## 1139 Hardware Update

February 2008

Effective February 2008, all 1139 Wireless Bill Traps are now manufactured with updated Level B hardware.

### Updated Hardware

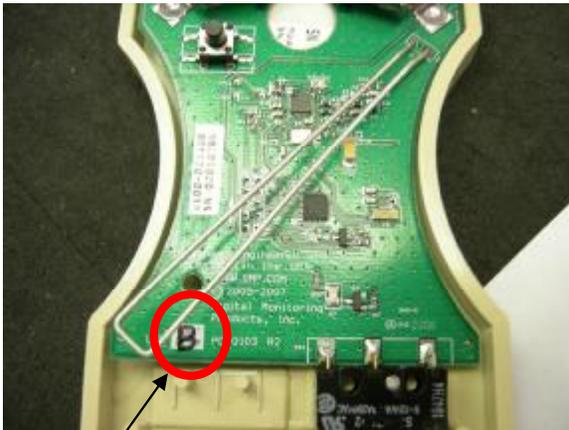
New Level B hardware for the 1139 Wireless Bill Trap corrects an issue where a low battery condition occurred after 4 – 6 months of normal operation. The Level B hardware provides the expected 1 year of battery life for the 1139.

To update, return any older Level A 1139 Bill Traps to DMP and simply indicate "Update to Latest Hardware Level B" on the RMA tag. The update will be done as a Warranty Repair at no charge, regardless of when the 1139 was purchased. If you need RMA tags, contact DMP Customer Service at 1-800-641-4282.
